later than promised, here some more open discussion points of V1.00 RC1 with some comments and questions.

Subject: Re: V1.00 RC1: open discussion points, part 2
Posted by [Matthias Hengartner](#) on Tue, 02 Nov 2004 11:25:57 GMT
[View Forum Message](#) <> [Reply to Message](#)

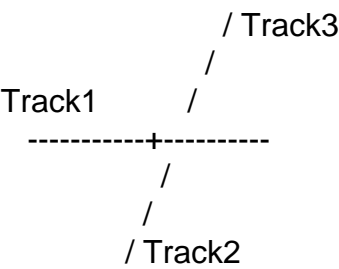
> I'm afraid I don't understand well the idea of 0...3 connections. 0
> connections are for crossings, 1 for single crossing switches (EKW) and 2
> for double crossing switches (DKW), am I right? But 3 connections?
> This means that a EKW has 1 connection ID (Right or wrong?), but for
> interlocking it needs 2 because it has 2 independent point machines with 2
> independent pairs of blades.

If we have a <track> (Track1, see below) with any <crossing> (+), there are 2 <connection>-elements, one "incoming" and connected with Track2, the other "outgoing" and connected with Track3. So it doesn't matter if it's a

single/double crossing switch or a simple crossing.

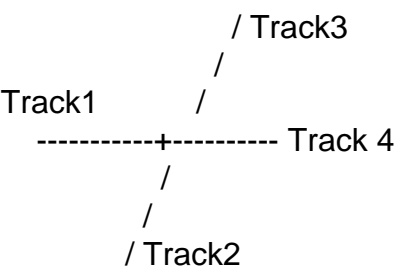
The possibility to have 3 <connection>-elements is (as far as I know) only needed if we have a crossing on a <trackBegin>/<trackEnd>. In the case which is illustrated below, there is a crossing at the end of Track1, and we have 2 "outgoing" connections to Track3 and Track4 and 1 "incoming" connection to Track2.
